**SUBJECT:** NuScale Power, LLC Response to NRC Request for Additional Information No. 403 (eRAI No. 9362) on the NuScale Design Certification Application

NuScale Response to NRC Request for Additional Information eRAI No. 9362

**NRC Question No.:** 03.08.02-15

Figure 3.8.2-10: **ECCS Trip/Reset Actuator Valve Pressure Boundary**

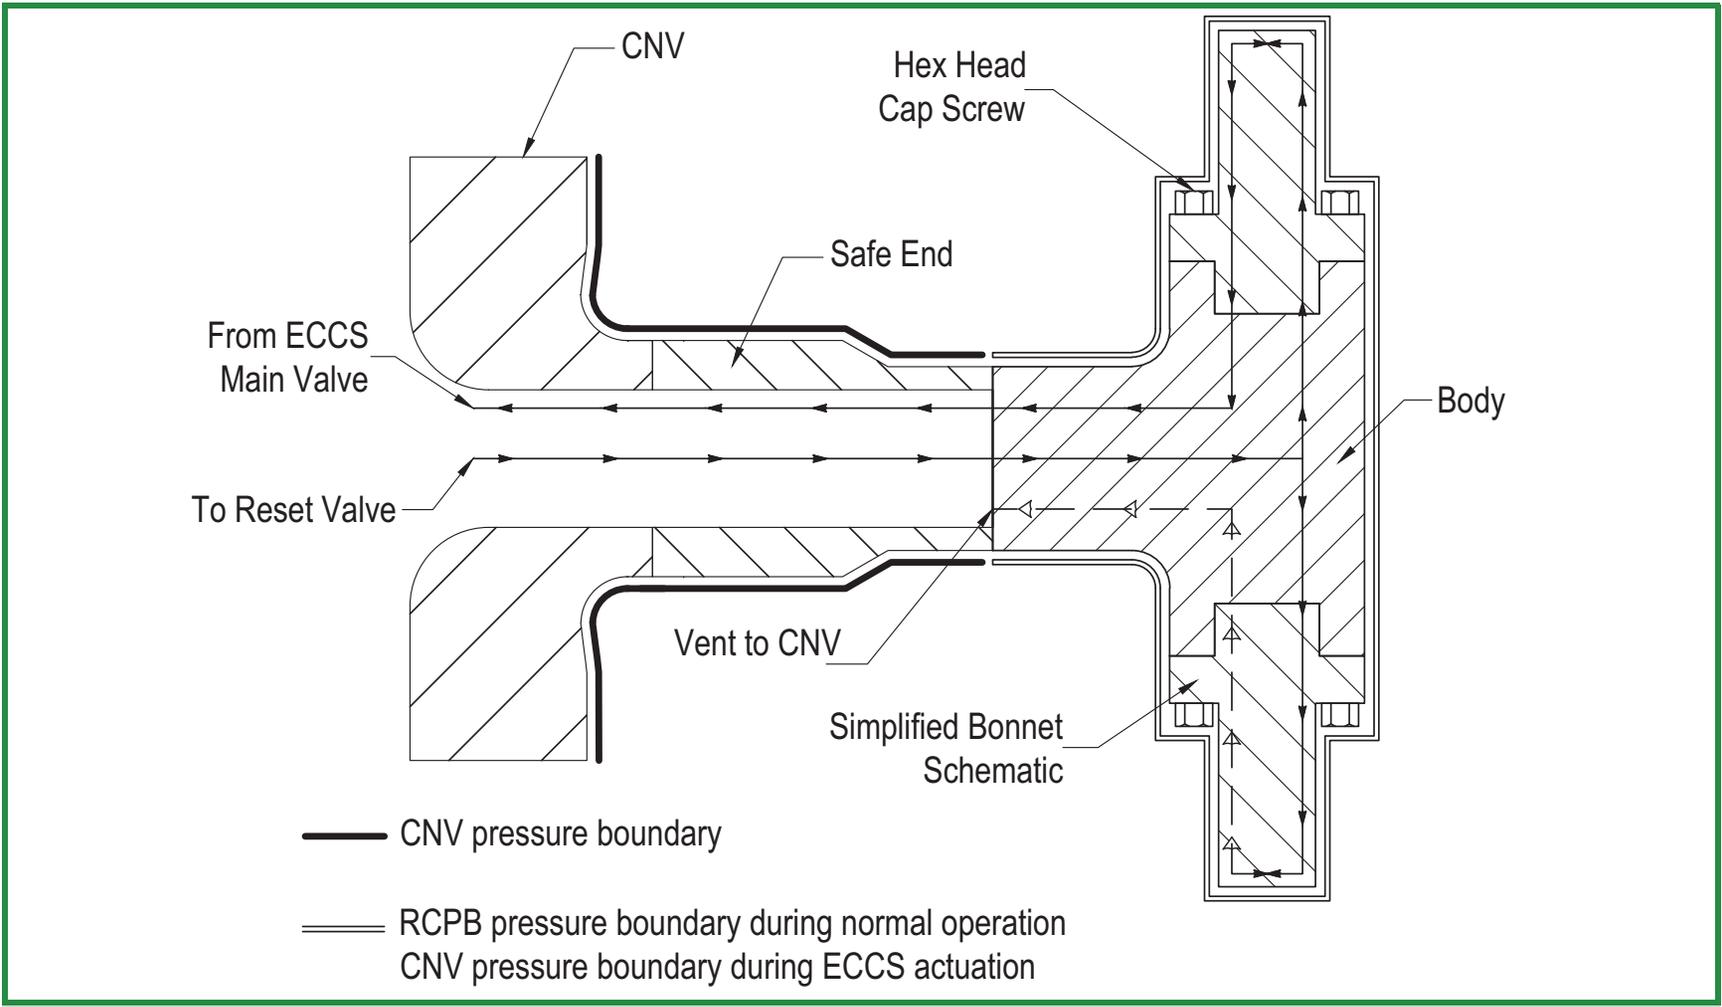
In relation with RAI 9315, Question 03.08.02-14, the DCD should be updated to include a drawing that clearly shows entire CNV pressure boundary, showing how it extends beyond the main CNV body to include the ECCS trip and reset solenoid valve assembly.

Figure 3.8.2-10 has been added to FSAR Tier 2, Section 3.8.2 to identify the containment vessel (CNV) pressure boundary and reactor coolant pressure boundary (RCPB) for the emergency core cooling system (ECCS) trip/reset actuator valve. The figure shows that the CNV penetration and safe end contain two small hydraulic tubing lines 1/2 inch diameter or less inside of the penetration. These hydraulic lines connect to the valve body at the end of the safe end. The tubing wall forms the RCPB and the penetration and safe end form the CNV pressure boundary. No hydraulic tubing lines extend past the safe end. Reactor coolant system (RCS) fluid enters the ECCS trip/reset actuator valve, which is attached outside of containment, through the hydraulic line. Fluid in the hydraulic lines connected to the valve is a static flow path during operation and are not subject to RCS transient conditions. Flow only occurs in the hydraulic lines when the ECCS valves open and pressure in the lines is vented through the ECCS trip/reset actuator valve and into containment. When the ECCS trip/reset actuator valve is closed the CNV pressure boundary stops at the valve attachment weld and the ECCS trip/reset actuator valve forms the RCPB. When the ECCS trip/reset actuator valve opens the valve is open to containment and the valve then forms the CNV pressure boundary. The ECCS trip/reset actuator valve is evaluated to the same American Society of Mechanical Engineers

The penetration and safe end for the ECCS trip/reset actuator valve does not carry fluid to the valve. Inside of the penetration and safe end is hydraulic tubing with RCS fluid from the ECCS main valve. Out of the valve and into the safe end is hydraulic tubing connecting to another trip/reset valve, and an opening that vents to containment when the valve trips. The hydraulic tubing extends the RCPB to the valve. The valve forms the RCPB during normal operation. Once the ECCS RVV and RRV trip the ECCS trip/reset actuator valve opens to containment. The valve is then open to the RCS and CNV and then becomes the containment pressure boundary. A discussion of the operation of the ECCS trip/reset actuator valve is provided in Section 6.3.2.2. Figure 3.8.2-10 shows the pressure boundaries on a simplified schematic of the ECCS trip/reset actuator valve on the safe end.

There is no piping attached to the ECCS trip/reset actuator valve outside of containment and only the small diameter tubing inside of containment. Per ASME BPVC Paragraph NB-1131 the boundary of a Class 1 vessel shall not be closer than a vessel than the first circumferential joint in welded connections, but does not restrict the boundary to be extended past the first welded connection. Since there is no piping connected to the valve outside of containment and only small diameter hydraulic tubing connected to the valve inside of containment the ECCS trip/reset actuator valve attachment weld to the safe end belongs to the CNV.
